CHANGES FOR SECTION 96 APPROVAL

CLIENT:
DEE WHY RSL CLUB

PROJECT:
STAGE 5 - CLUB EXTENSION

SCALE:	DATE:
As indicated @ B1	MARCH 2018
DRAWN BY: MC	CHECKED BY: DOC
PROJECT NO: 2341.06	DRAWING NO: DA-9000
CAD FILE:	ISSUE: 2

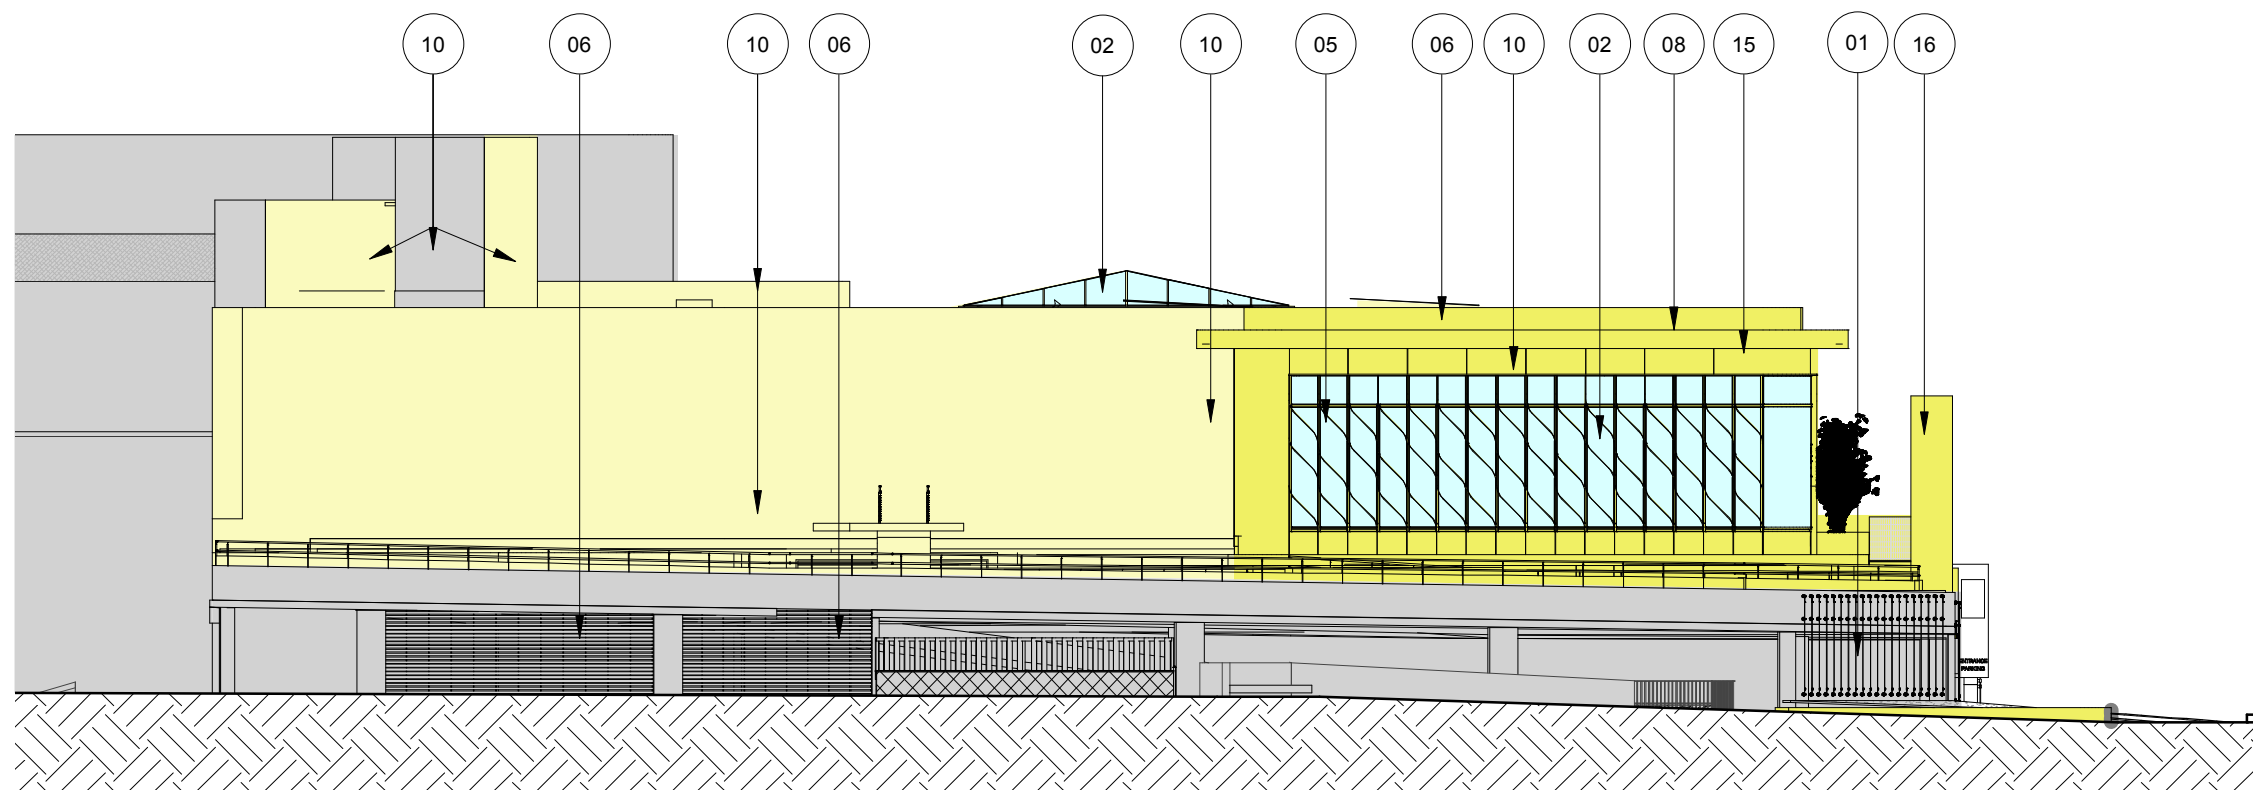
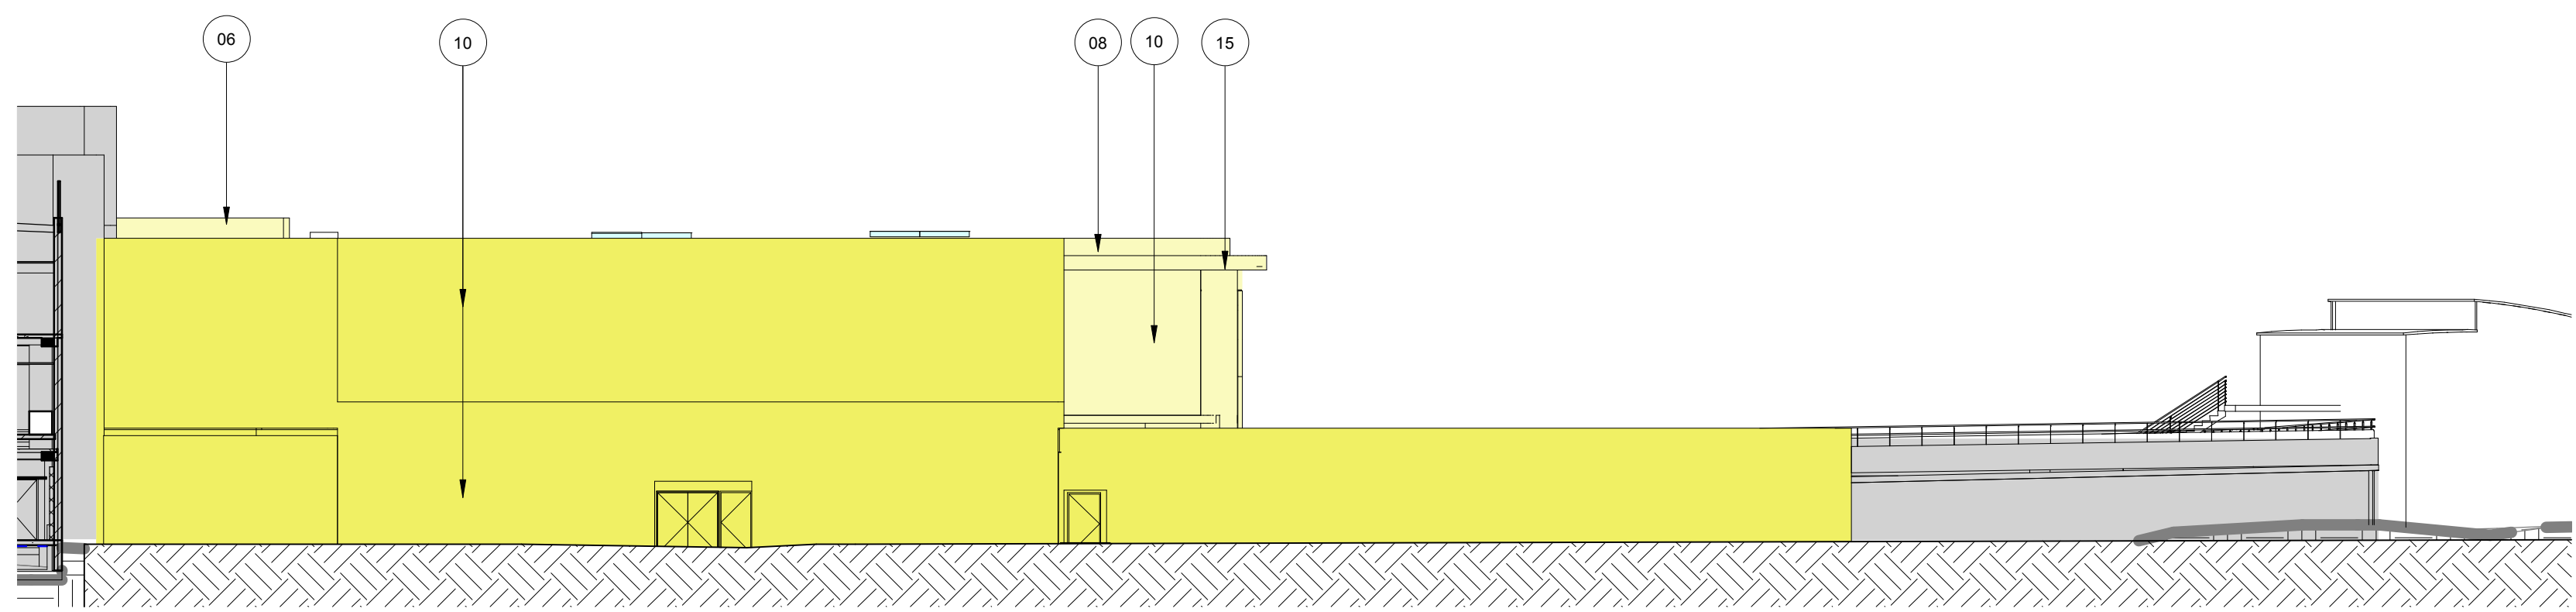
- roof
1. RELOCATED OPEN PLANTROOM AT THE ROOF LEVEL
 2. MODIFIED ROOF OPENING ABOVE MAIN ENTRANCE
 3. MODIFIED CENTRAL SKYLIGHT (REDUCED HEIGHT, MODIFIED PITCH)
 4. MODIFIED COURTYARD: TWO OPEN COURTYARDS AND ONE SKYLIGHT COVERED AREA INSTEAD OF ONE LARGE GLASS ROOF. REDUCED HEIGHT AND PITCH
 5. MODIFIED SMOKING TERRACE: ROOF OPENING, SIZE AND PLANTED AREA. AREA REDUCED BY 33m²
 6. REDUCED NUMBER OF ROOF SKYLIGHTS ABOVE ASIAN RESTAURANT. 2 INSTEAD OF 6 TO SUIT THE NEW INTERNAL LAYOUT
 7. MODIFIED EXIT STAIR: POSITION, CONFIGURATION, METAL ROOF NO LONGER REQUIRED
 8. CONCRETE ROOF INSTEAD OF METAL DECK ROOF FOR THE MAJORITY OF THE BUILDING EXTENSION
 9. NO SLAB ABOVE THE EXPOSED CAR PARK LEVEL 2 IN THE SOUTH AREA
 10. NEW ACOUSTIC METAL ROOF ABOVE REVISED LOADING DOCK

- facade
11. MODIFIED FACADE APPEARANCE DUE TO CHANGES IN THE CAR PARK LEVELS, LOADING DOCK AND EGRESS STAIRS
 12. REMOVED LOUVRES ON THE BACK FACADE (WESTERN FACADE) DUE TO MECHANICAL RISER NO LONGER REQUIRED / REVISED LOCATION FOR EGRESS DOORS
 13. 2m WIDE INTERNAL EGRESS STAIR MODIFIED INTO TWO 1m WIDE EXTERNAL STAIRS WITH DECORATIVE BALUSTRADES
 14. EXTENT OF LEVEL 2 (MAIN TRADING LEVEL) REDUCED BY 8326mm FROM THE SOUTHERN BOUNDARY AND INCREASED BY 1100mm TO THE EASTERN BOUNDARY
 15. MODIFIED FACADE CURTAIN WALL MULLION BLADES
 16. CONCRETE BLADE WALL REDUCED BY 1.47m IN HEIGHT AND 6.2m IN LENGTH
 17. VERTICAL FINS REMOVED FROM BACK WALL (WESTERN FACADE)

- ground/landscape/floor plate
18. REVISED LOADING DOCK ENTRANCE AND LOCATION/ ENLARGED DEMOLISHED AREA IN THE EXISTING RETAINED SOUTHERN CAR PARK
 19. NEW / MODIFIED EGRESS PATHS FROM EXISTING CARPARK LEVEL -1. NEW CARPARK LEVEL 1.

20. RELOCATED ELECTRICAL SUBSTATION / LANDSCAPED AREA MOVED TO SUIT
 21. MEDIAN STRIP ADDED AT ENTRY TO PROVIDE PLACE OF REFUGE AND ENSURE WIDTH OF ENTRY/ EXIT IS LESS THAN 9M AS PER DA CONDITION 23

22. RELOCATED STORMWATER OVERFLOW PATH
 23. EXTENT OF BASEMENT CAR PARK LEVELS REDUCED. BASEMENT REDUCED BY 14394mm FROM THE WEST BOUNDARY. BASEMENT ENLARGED BY 280mm TOWARDS THE SOUTH BOUNDARY. CARPARK CHANGED FROM FLAT PLATE TO SPLIT LEVEL ON ALL LEVELS. DEPTH OF CAR PARK INCREASED FROM RL - 3.600 TO RL - 5.700. OVERALL PARKING SPACES REDUCED FROM 687 TO 680

24. BASEMENT CAR PARK LEVEL -5 ADDED.
 25. CAR PARK ENTRY / EXIT MOVED TOWARD NORTH BY 3044mm
 26. PLANTER MODIFIED ON THE BACK (WESTERN) FACADE DUE TO REDUCTION OF THE MAIN TRADING FLOOR SLAB

27. LOCATION OF AIR INTAKE MODIFIED
 28. EXTENT OF RESTAURANT REDUCED BY 135m²
 29. CLUB ENTRANCE ACCESSIBLE RAMPS MODIFIED
 30. ONE ADDITIONAL EXISTING CAR PARK SPACE TO BE REMOVED FROM EXISTING NORTHERN CAR PARK.

31. SOLID MASONRY WALL ADDED BETWEEN EXISTING ZONE D CAR PARK AND LOADING DOCK ACCESS.
